Missouri Department of Natural Resources
Air Pollution Control Program
2016 Monitoring Network Plan

November 15, 2016

**APPENDIX 6: COMMENTS AND RESPONSES ON PROPOSED 2016 MONITORING
NETWORK PLAN, REVISION 0**

**APPENDIX 7: COMMENTS AND RESPONSES ON PROPOSED 2016 MONITORING
NETWORK PLAN, REVISION 1**

Figure 17. Receptors with the 10, 25, 50, and 100 highest score ranks (clockwise from upper left). Peak concentration areas (design value $>90 \text{ ug/m}^3$) are shaded red.

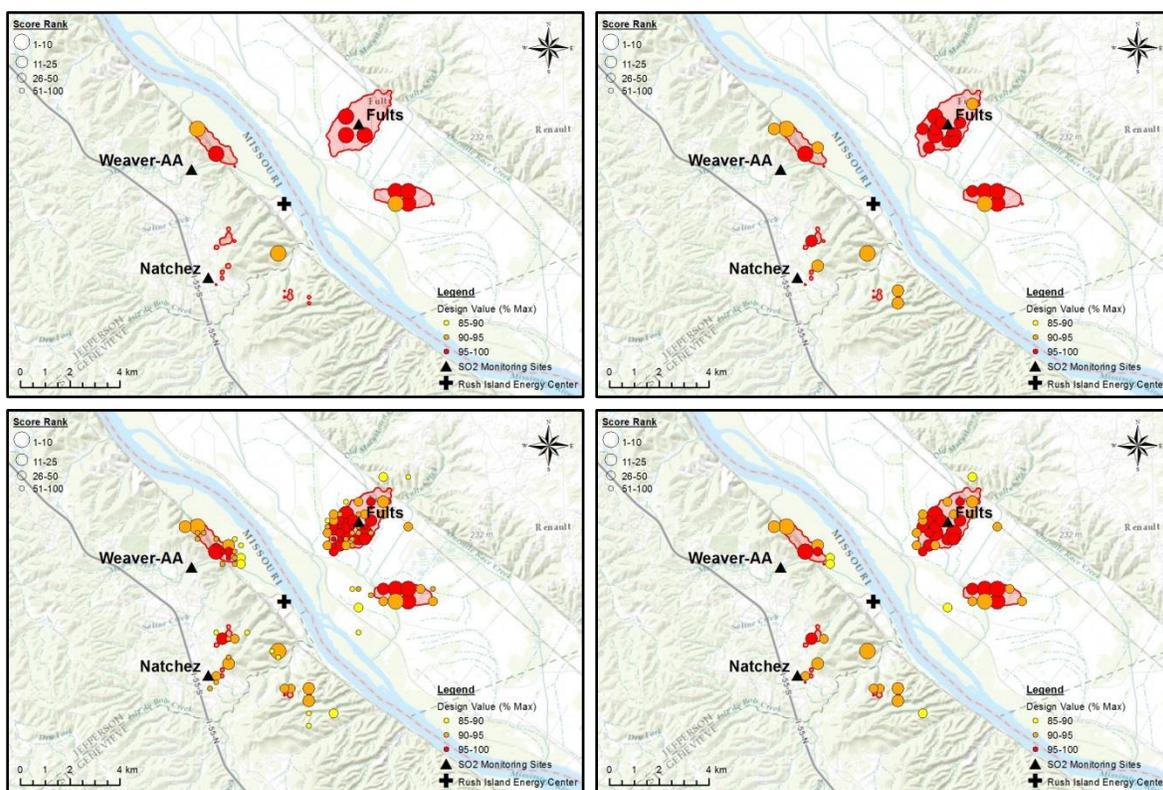
Had DNR followed the scoring strategy described in the TAD through to the end, and ranked receptors by their scores to come up with a list of locations ranked in general order of desirability with regard to monitor siting, its supplemental analysis would have reached a different conclusion regarding the siting of the Rush Island monitors. Figure 17 shows the 10, 25, 50, and 100 receptors with the highest score ranks superimposed on the peak concentration areas (design value $>90 \text{ ug/m}^3$). The 10 receptors with the highest score ranks would be the most desirable monitor locations, and all but one are clustered in the three largest peak concentration areas, which are where the Rush Island SO_2 monitors should have been sited. The fact that almost all of the 10 highest ranked receptors – taking into account modeled design values *and* frequency of having the highest 1-hour daily maximum concentration – are located in these areas only reinforces that point. Similar results are obtained by looking further down the priority list at the 25, 50, and 100 highest ranked receptors, the vast majority of which are located in the same three peak concentration areas.

Figure 21. Receptors with the 10, 25, 50, and 100 highest score ranks (clockwise from upper left) based on 2013-2015 data

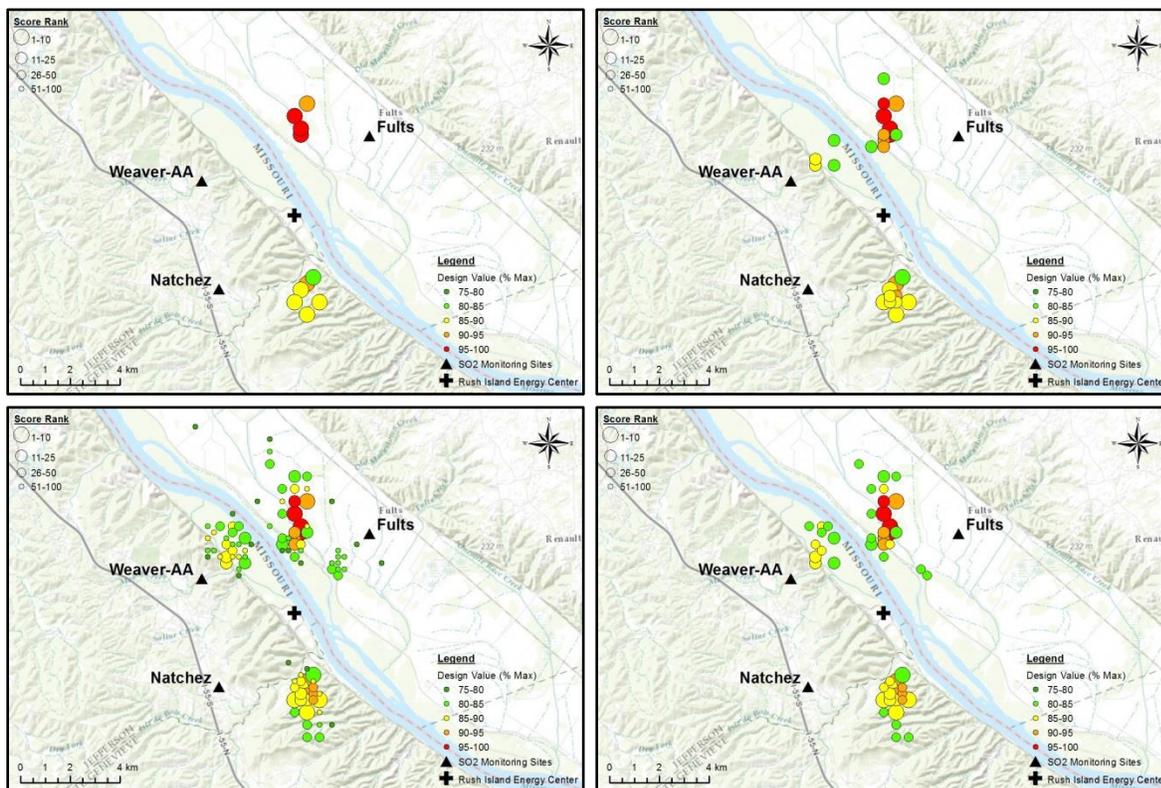
When 2013-2015 data are used, the highest concentration areas shift and are located immediately north and south of the plant instead of to the east, northeast, and northwest, as shown in Figure 18. The receptors with the lowest scores – i.e., those with the highest combined concentration rank (based on modeled design value) and day rank (based on frequency of having the highest 1-hour daily maximum concentration) – are similarly located north and south of the plant, as shown in Figure 20. Furthermore, when the top receptors are ranked by score so as to provide a list ranked in general order of desirability with regard to siting monitors in accordance with the Monitoring TAD, there are no high-ranking receptors near any of the existing monitors. Figure 21 shows the 10, 25, 50, and 100 receptors with the highest score ranks based on modeling using 2013-2015 data.

Figure 1. Receptors with modeled design values 75 percent of the maximum design value.

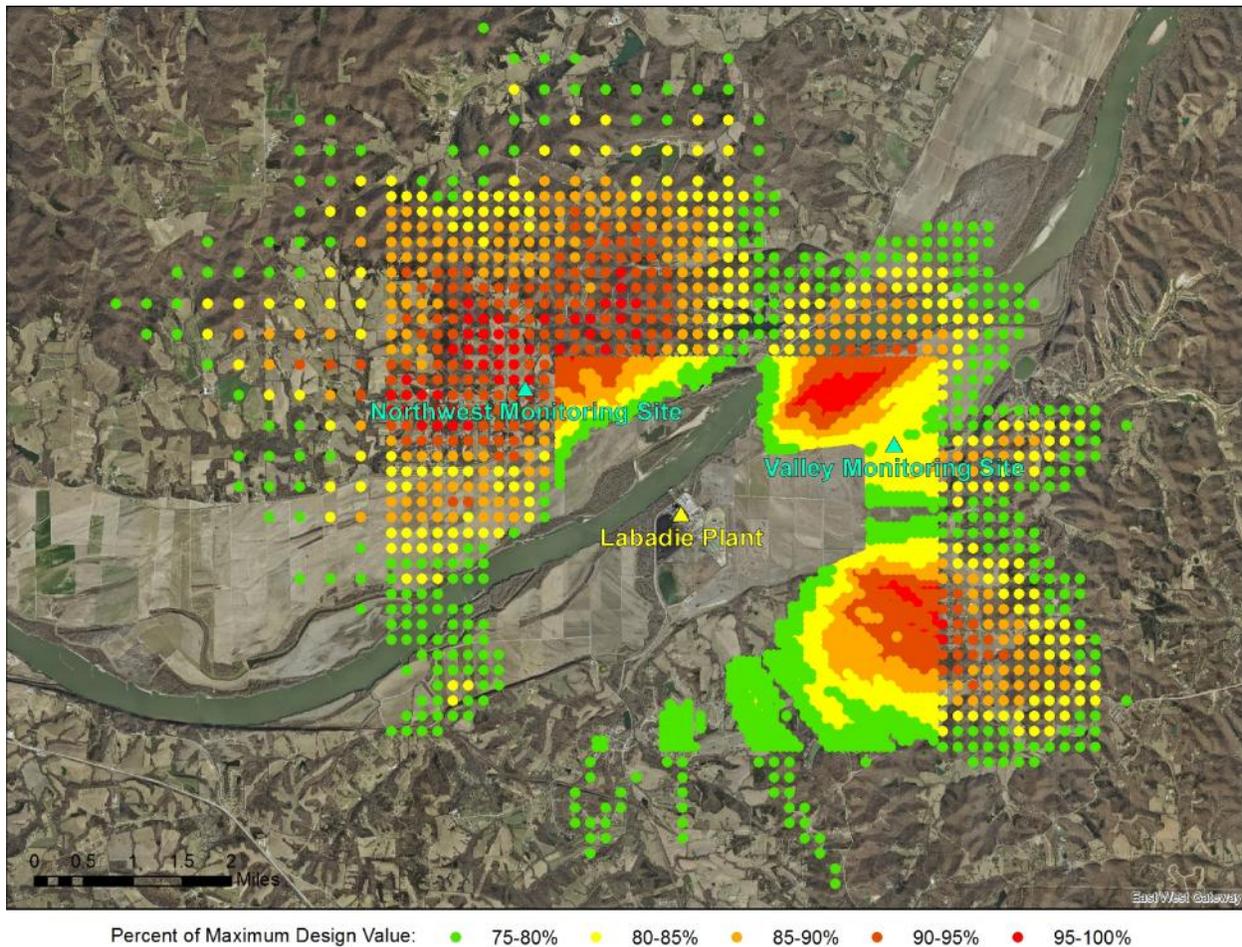
Appendix 10 of the QAPP describes the modeling performed to determine the locations of the proposed ambient SO₂ monitoring stations around the Labadie Energy Center. The modeling was used to determine locations where peak 1-hour SO₂ concentrations are expected to occur due to the plant's SO₂ emissions given that the primary objective of source-oriented monitoring is to identify peak SO₂ concentrations in ambient air that are attributable to an identified emission source or group of sources.¹ Figure 1 shows all receptors with modeled design values greater than or equal to 75 percent of the maximum modeled design value. Figure 2 shows the receptors with the top 200, 100, 25, and 10 modeled design values.

Figure 3. Number of maximum daily 1-hour SO₂ concentrations at each receptor that exceed 75 percent of the maximum modeled design value.

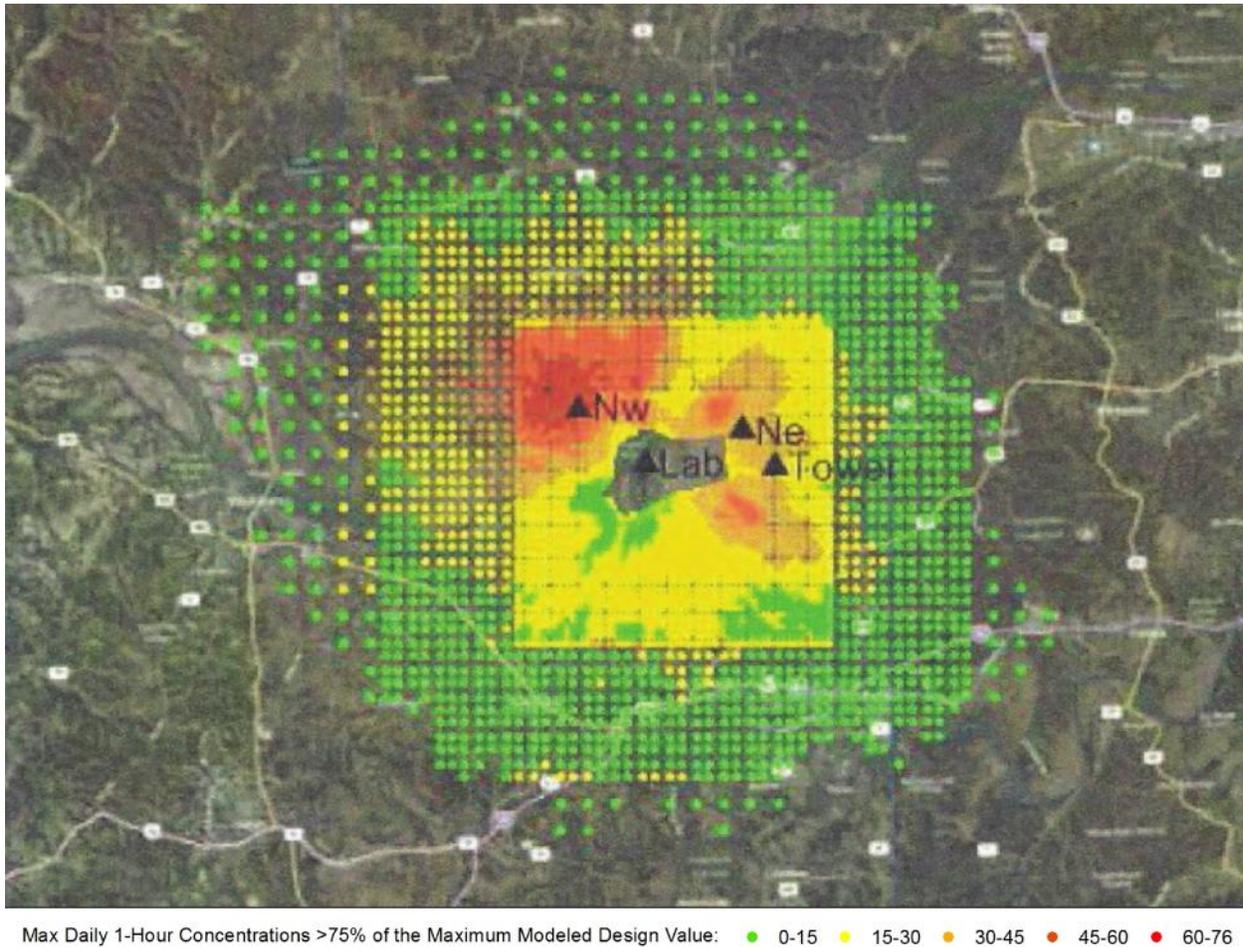
The modeling was also used to determine locations where elevated SO₂ concentrations are expected to occur most frequently given that the site selection process also needs to account for the frequency with which an area sees the daily maximum concentration.² Normally this involves counting the number of times each receptor sees the daily maximum 1-hour SO₂ concentration predicted by the model. However, the QAPP looks at it differently, counting instead the number of times the daily maximum 1-hour SO₂ concentration at each receptor exceeds 75 percent of the maximum modeled design value. Figure 3, which is reproduced from the QAPP,³ shows the number of daily maximum 1-hour SO₂ concentrations at each receptor that exceed 75 percent of the maximum modeled design value.

Figure 4. Top 10, 25 and 50 receptors and filled contour plot of modeled design values.

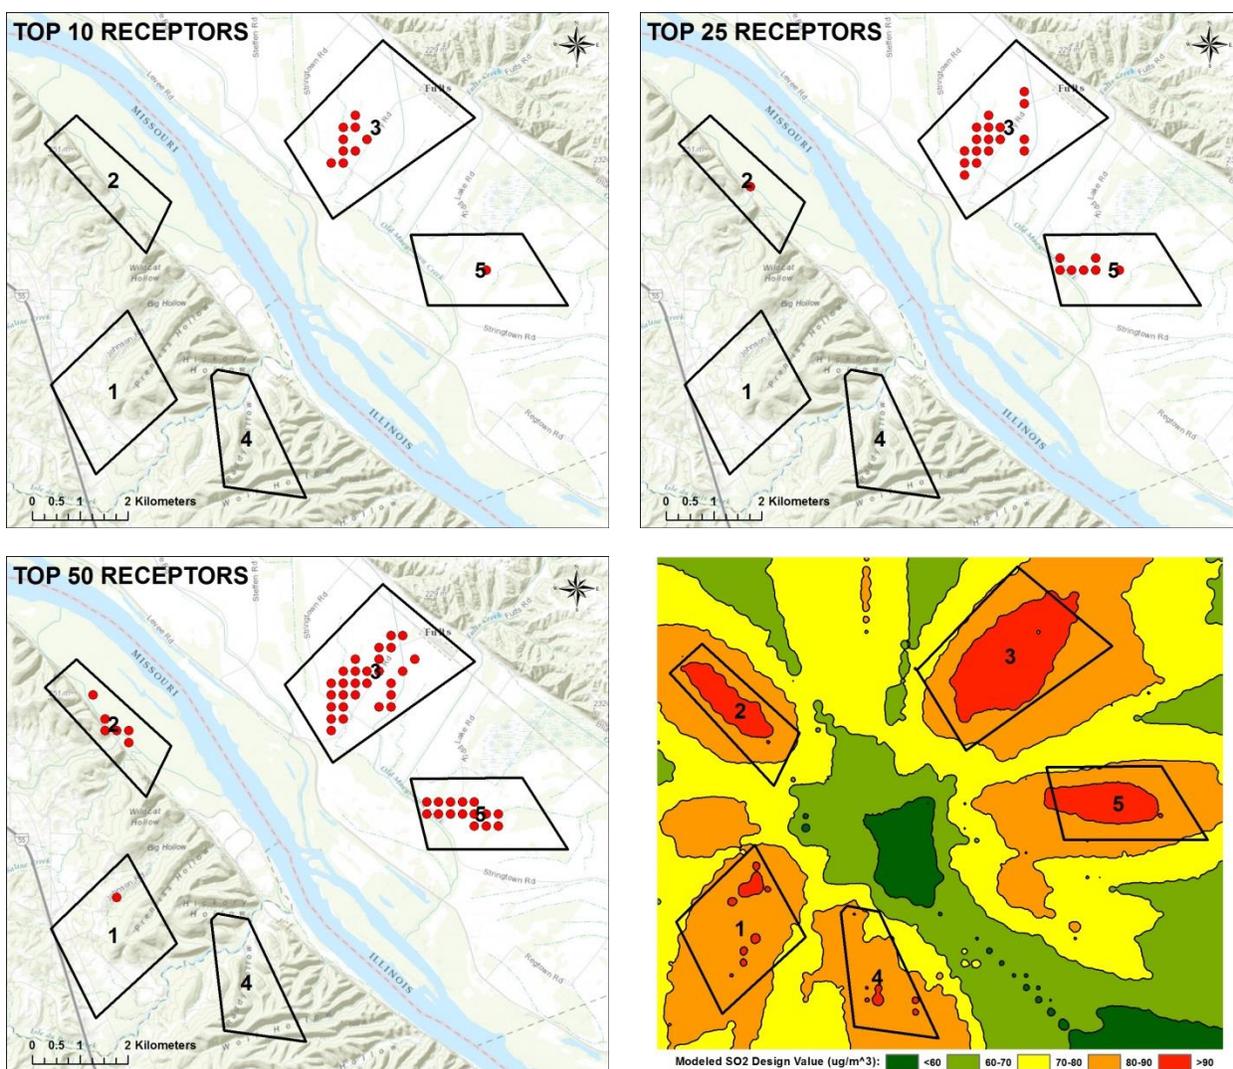
When modeled with a uniform receptor grid, the three highest ranking polygons – both in terms of the number and percentage of high concentration receptors they contain – are 2, 3 and 5, **not** 1, 2 and 3 as DNR's flawed analysis concluded. These are the areas predicted to have the highest modeled impacts and thus where SO₂ monitoring sites should be located. An analysis of the top 10, 25, and 50 receptors supports this conclusion. All but one of the top 10 receptors are located within polygon 3, all but one of the top 25 receptors are located within polygons 2 and 3, and all but one of the top 50 receptors are located within polygons 2, 3 and 5. This is shown in Figure 4 below, which includes a filled contour plot of modeled design values that clearly shows how much larger the peak concentration areas are in polygons 2, 3 and 5 compared to the other polygons.

Figure 1. Expected peak SO₂ concentration areas per Ameren’s modeling.

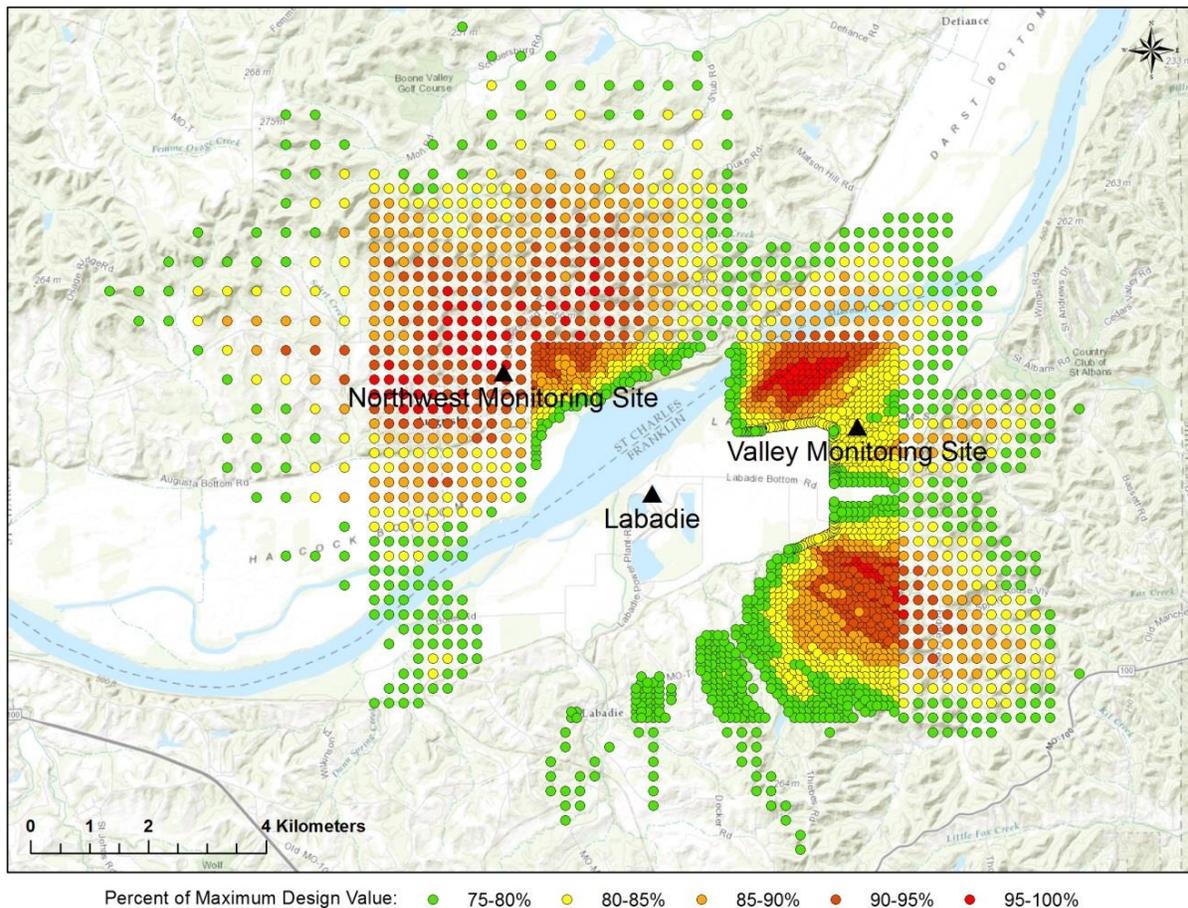
identified three distinct areas where peak SO₂ concentrations are expected to occur. These areas, demarcated by orange and red receptors, are located northwest, northeast, and southeast of the plant and are shown in Figure 1 below. However, only one of the two new monitoring sites – the Northwest site – is located in a peak concentration area as modeled by Ameren. The Valley monitoring site is located between the other two Ameren-modeled peak concentration areas, in an area where the modeled concentration is only about 80 percent of the maximum concentration predicted by Ameren’s model.

Figure 2. Expected peak SO₂ concentration areas per DNR's modeling.

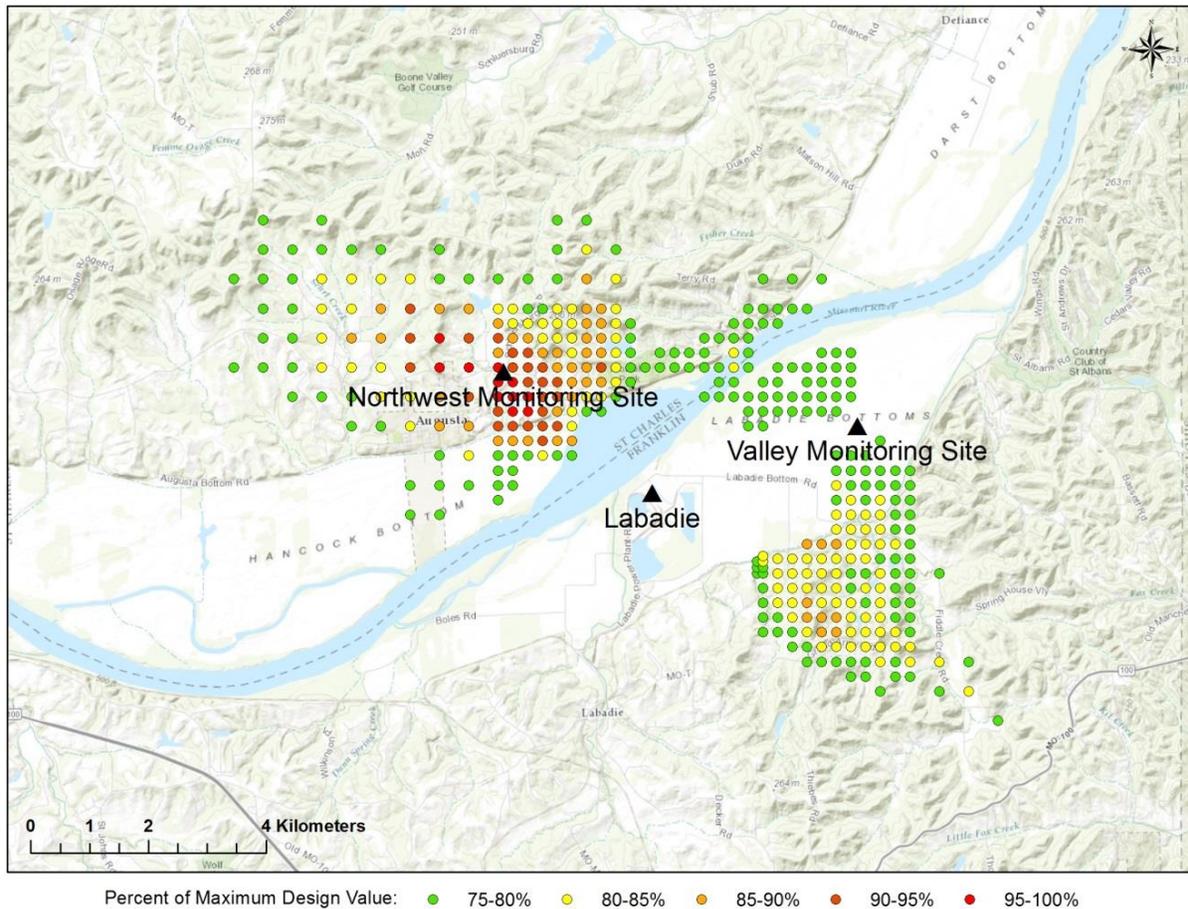
DNR's modeling, as illustrated by Figures 2 and 3, confirms that the Valley monitoring site is not located in an area where peak SO₂ concentrations are expected to occur. To the contrary, the Valley site is in an area where the modeled concentration is less than 75 percent of the maximum concentration predicted by DNR's model. DNR's modeling also confirms that there is an expected peak concentration area southeast of the plant with considerably higher modeled SO₂ design values than at the Valley monitoring site, yet with no monitor. DNR's model predicts NAAQS exceedances in this other area, but not at the Valley site.

Figure 6. Expected peak SO₂ concentration areas per DNR's modeling using KSUS instead of KJEF surface meteorological data.

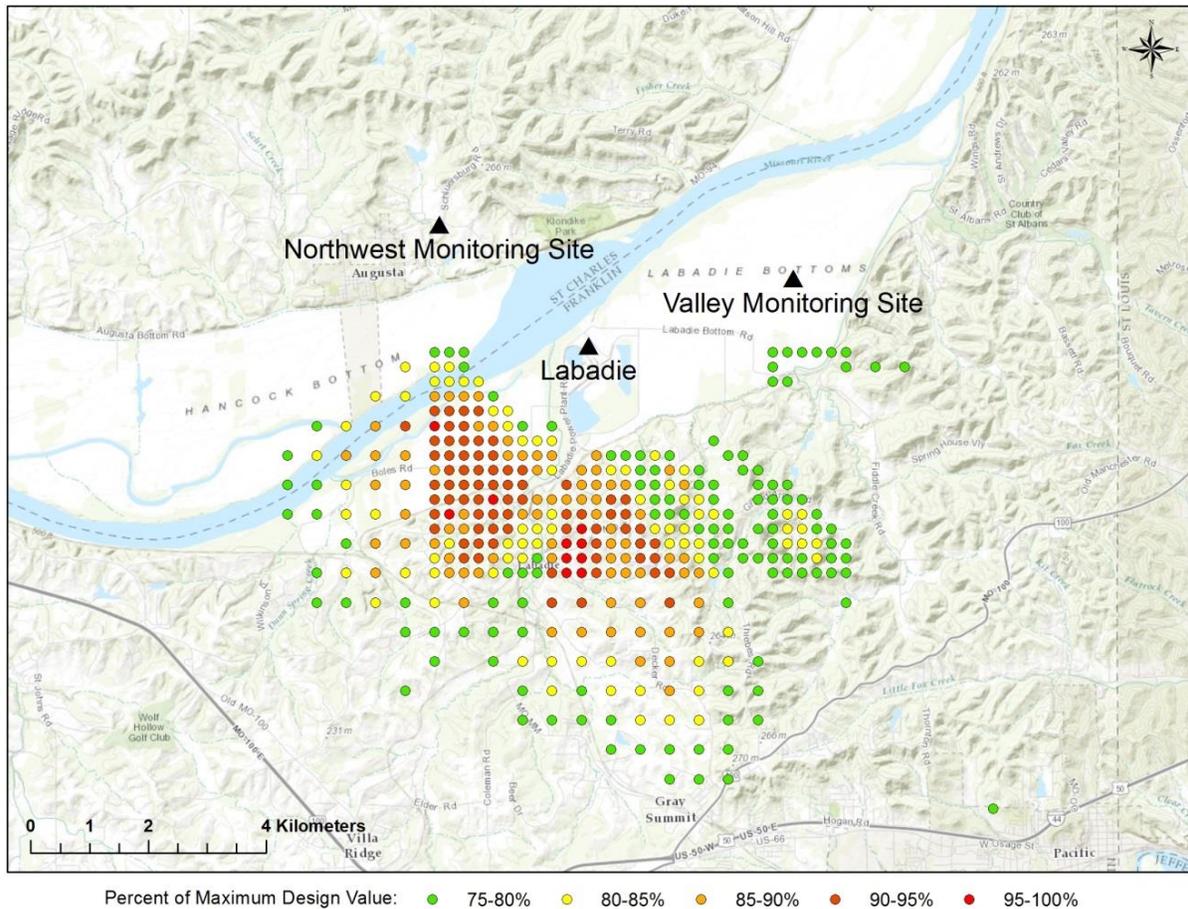
Figure 6 (see next page) shows peak concentration areas, demarcated by orange and red receptors, predicted by DNR's model when KSUS surface meteorological data is used instead of KJEF data. The results are striking; *if KSUS data is in fact more representative of the area than KJEF data, then neither the Valley monitoring site nor the Northwest monitoring site is located in an area where peak SO₂ concentrations are expected to occur and neither is appropriately sited for use in future NAAQS compliance evaluations.*
